digital		ORIGINATOR Tom Off 1-2 TEL EXT 2791 DATE 11/17/72 DISC PROJ NO E20-06734 COST CENTER NO 378		ECO NO. <u>M7254-0001</u> SHEET <u>1</u> OF <u>1</u> DATE RECEIVED <u>11-30-72</u> FIRST ISSUE <u>12-4-72</u> FINAL ISSUE <u>12-17-72</u>			
ENGINEERING CHANGE ORDER <u>9167</u>				UNIT TO BE CHANGED M7254 Etch REV C DISC CODE 03			
PROBLEM 1) RK11-D samples word count overflow at sector end time to determine if a transfer is complete. This gives premature termination of write and write check functions during short sectors. 2) Temporary availability problems with T.I.7427 #19-1087C				OPTIONS AFFECTED RK11-D,E			
CORRECTION 1) Use file done signal from M7256 instead of word count overflow for sample at sector end. 2) Add 8875 #19-10647 to parts list as an alternative to 7427.				PRODUCT LINES AFFECTED PDP-11			
BREAK-IN/EFFECTIVITY Rework all M7254 Rev C Loads.							
ITEM NO	DOCUMENT/PART NO	OLD REV	NEW REV	DISP CODE	DESCRIPTION OF CHANGE		
1.	D-CS-M7254-C-1	B	C	06	Sheets 1, 2, 4, & 6 -Sec final release drawing.		
2.	B-MH-M7254-0-6	A	A	06	See final release drawing.		
3.	XXXXXXXXXX	D	D	03	Make the following etch changes: 1) Delete: AP1-E0204, E02 13 2) Delete: E0602-A01 3) Add: AP1

THIS DRAWING IS PART OF E.C.O. PACKAGE # M7257-00012 NOT TO BE USED FOR PRODUCTION

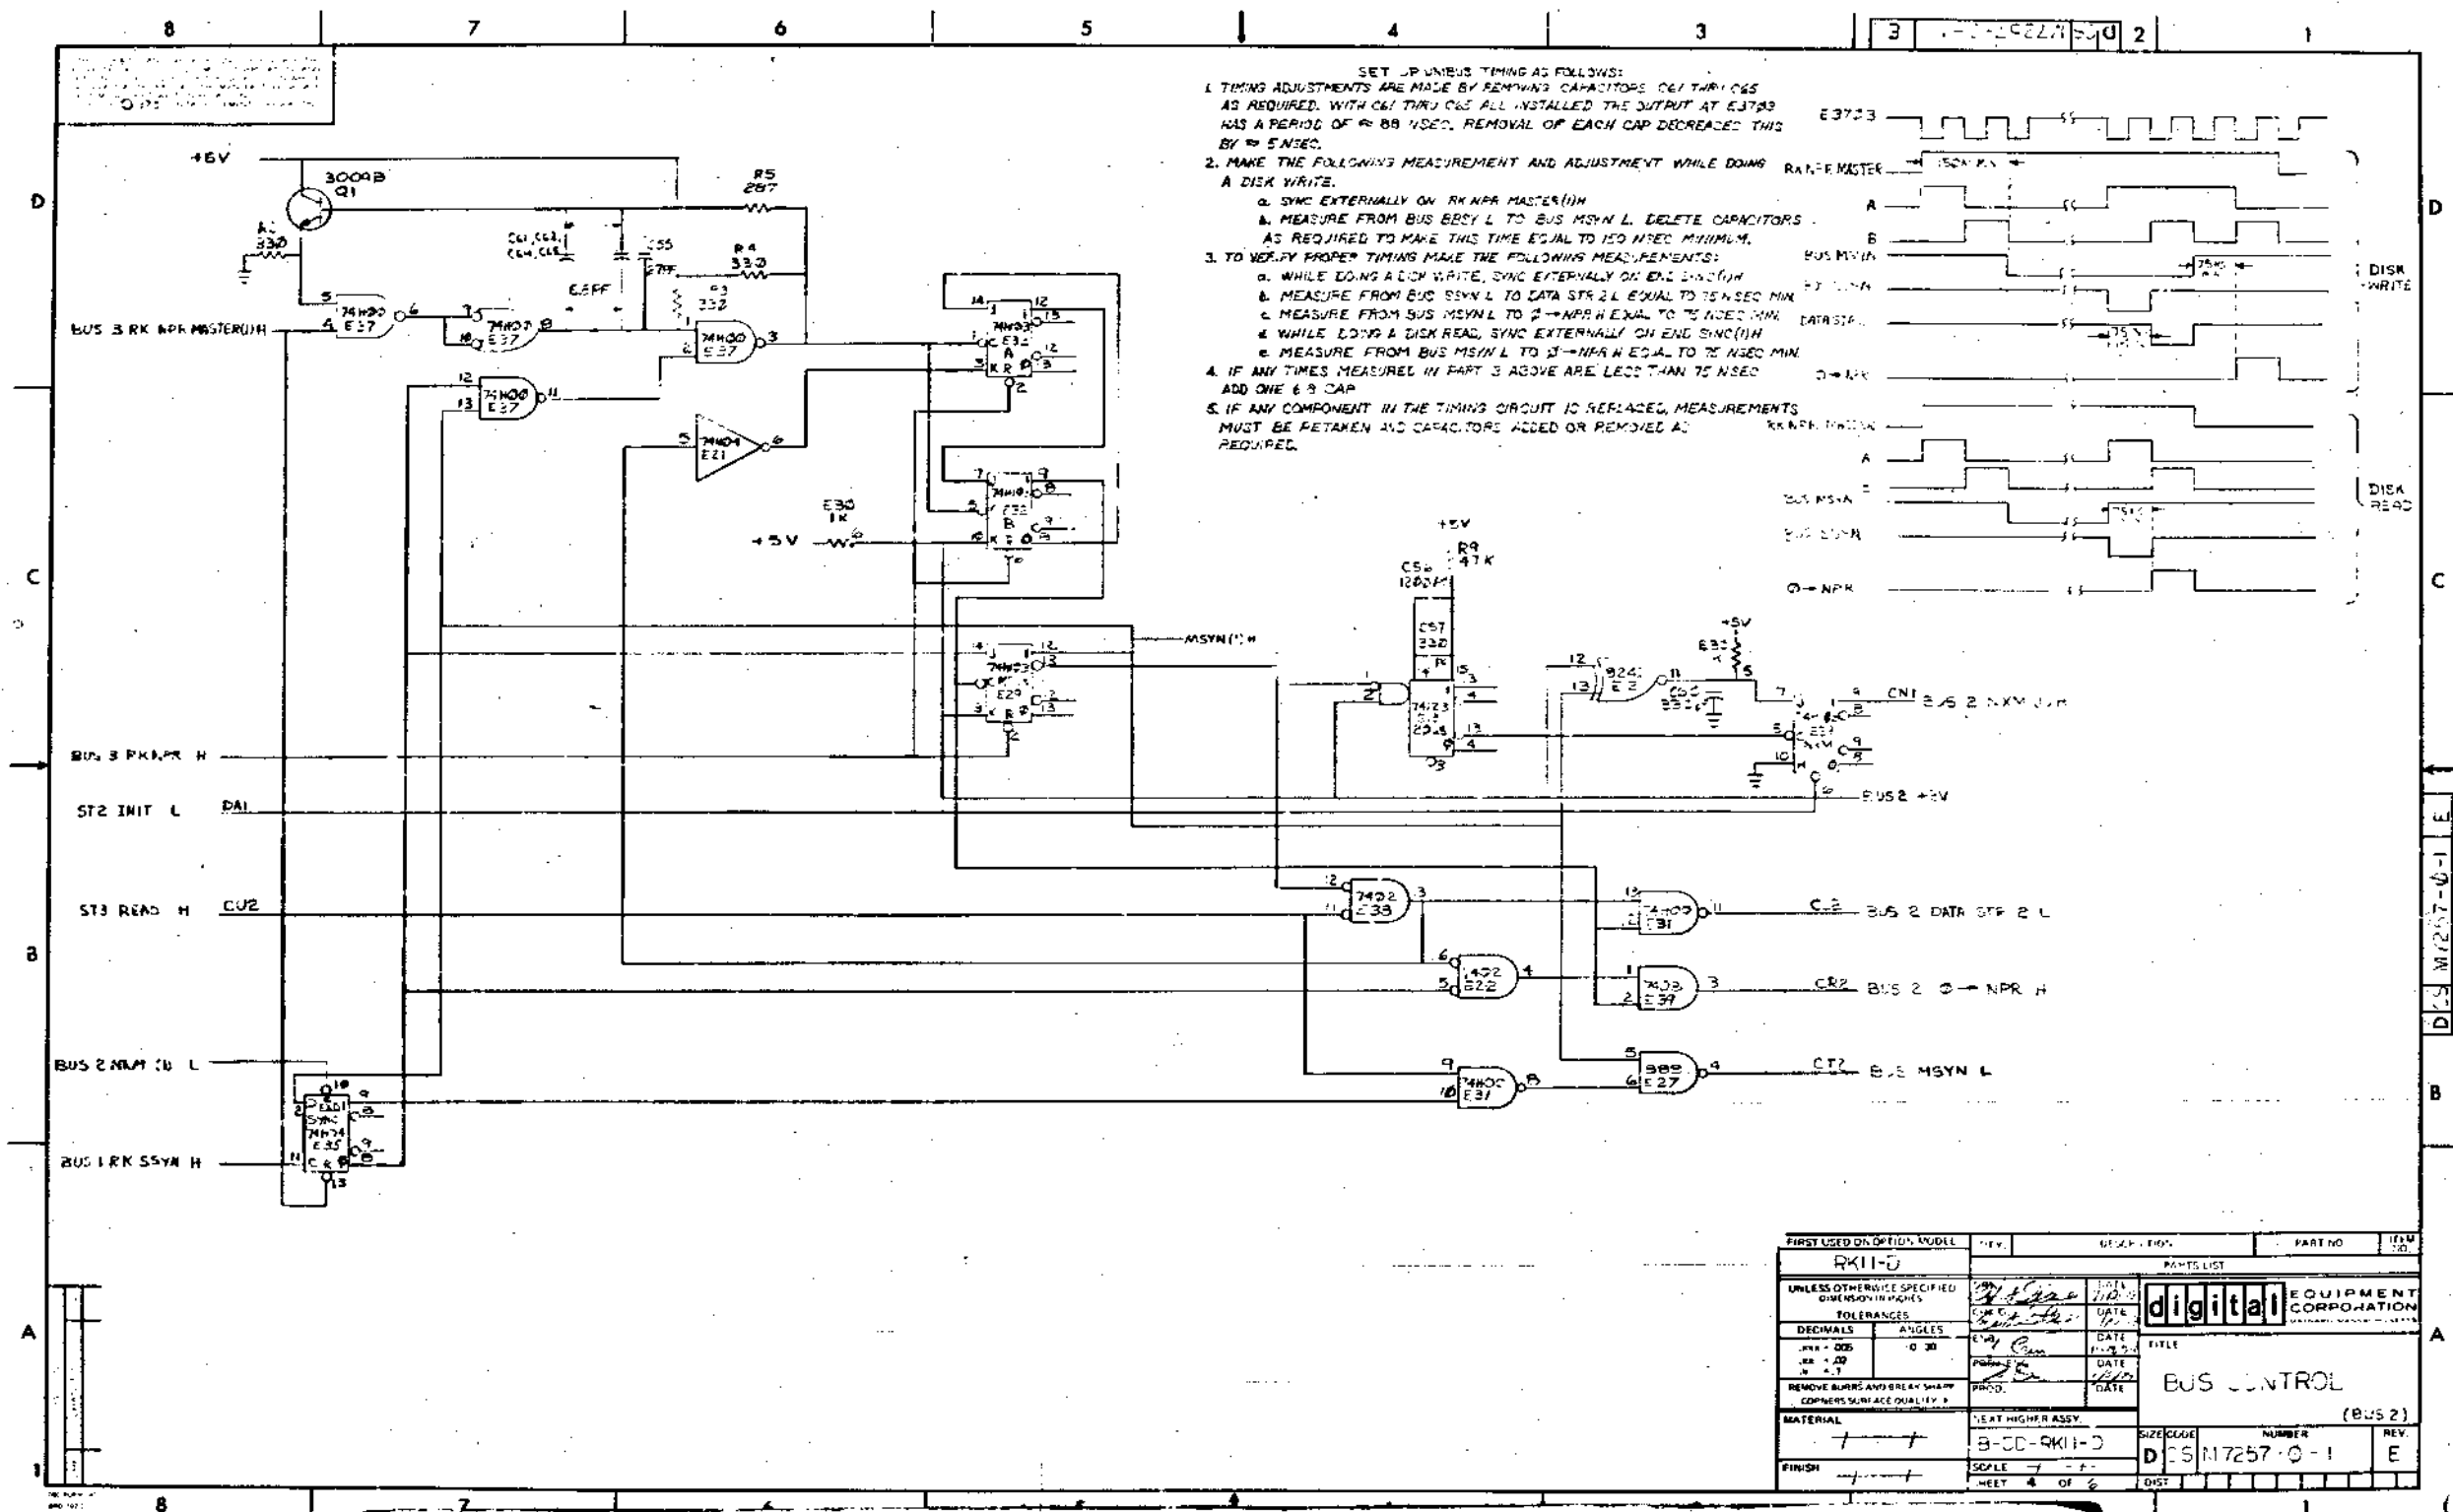
SET UP UNIBUS TIMING AS FOLLOWS:
 1. TIMING ADJUSTMENTS ARE MADE BY REMOVING CAPACITORS C61 THRU C65 AS REQUIRED. WITH C61 THRU C65 ALL INSTALLED THE OUTPUT AT E3723 HAS A PERIOD OF 88 NSEC. REMOVAL OF EACH CAP DECREASES THIS BY 5 NSEC.
